FIRE SAFETY INSPECTION REPORT

TECH MAX LTD.

Date: 24 October 2021

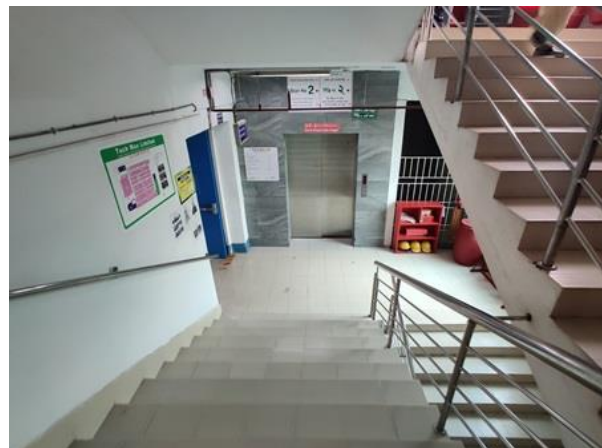
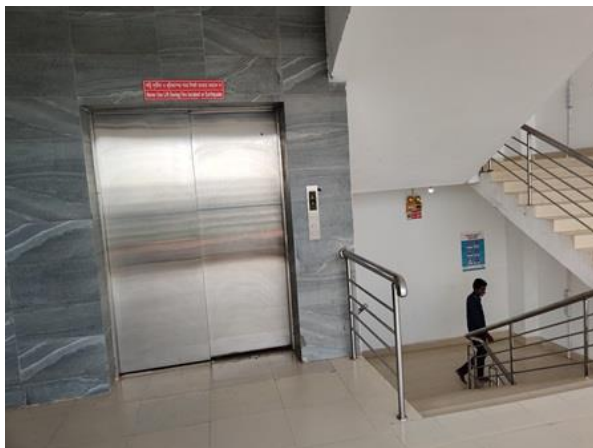
F-4	Fire Protection	Automatic sprinkler system installation requires detailed review to confirm compliance with NFPA 20 and ACCORD standards.	Submit as-built drawings, testing records, equipment certification and other relevant documentation to the RSC for review and approval/acceptance test.	Within 1 month
-----	-----------------	---	---	----------------
